Subject: Land Use Appeal of PLN160348/Black Crow LLC

Re: Meyer Appeal of PLN160348
Our File: 34910.33559

RE: Proposed Roof Deck – 2874 Pradera Road, Carmel Meadows

Proposed deck location at northwest corner of house

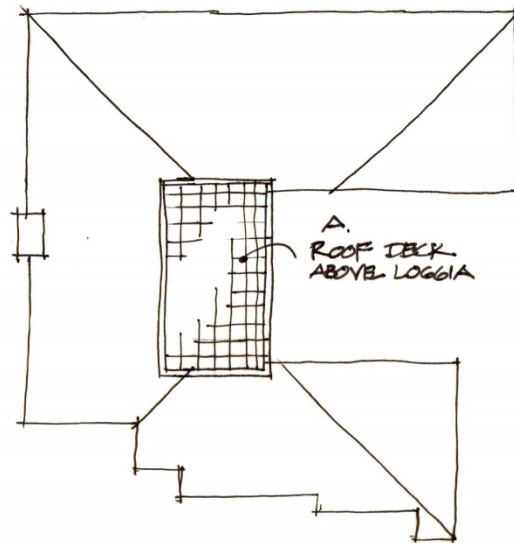
Here is a sketch of the proposed residence, showing the location of the deck at the northwest corner of the house:

Providing a greater distance between the proposed deck and the existing north neighbor's bedroom would go far to reduce intrusion on privacy and noise intrusion. In addition, if the deck is nestled into

the roof structure both visibility of the deck (not from the deck) and noise emanating from deck activity could be lessened considerably.

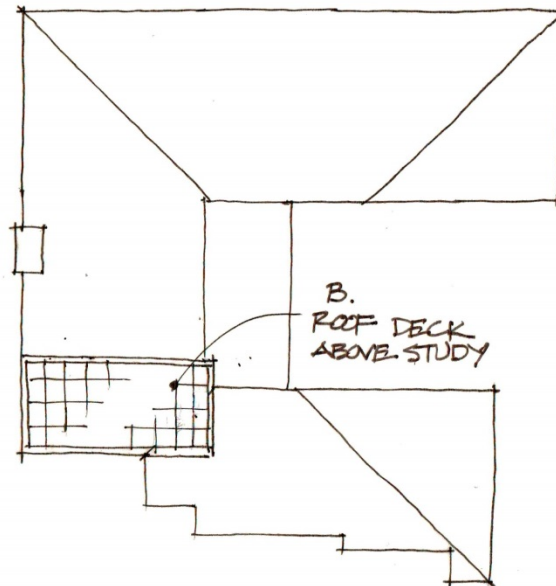
There may be any number of possible deck locations which would provide a great view deck for the proposed residence, while protecting the privacy of the south property and eliminating or minimizing the impact on Ms. Meyer's property. I have sketched three:

Option 'A' – Roof Deck above Entry Loggia: In this option the deck would be located on the flat roof area above the entry, far back from any neighboring properties while enjoying a panoramic view.

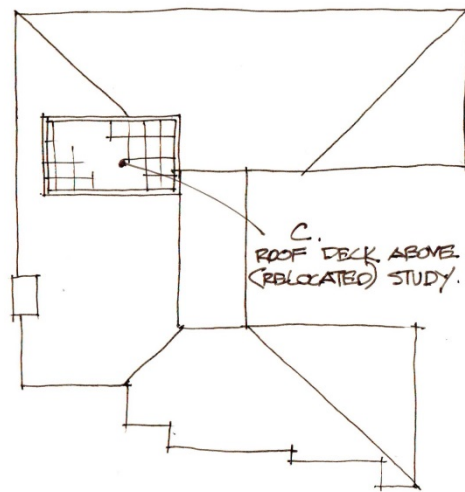
Option 'B' – Roof Deck above Study: Location of the roof deck over the study would avoid impacting the vaulted ceiling of the living space. It would be located closer to the south property, but based on the

house setbacks it would be a good distance (17'-4") from the south property line. Introduction of screen hedges on the south property line would further minimize any possible privacy issue.

Option 'C' – Roof Deck above relocated study: By reconfiguring the interior layout, the deck would be located in the north center of the roof, far away from the south property yet a sufficient distance from the north property line to better protect Ms. Meyer's privacy.
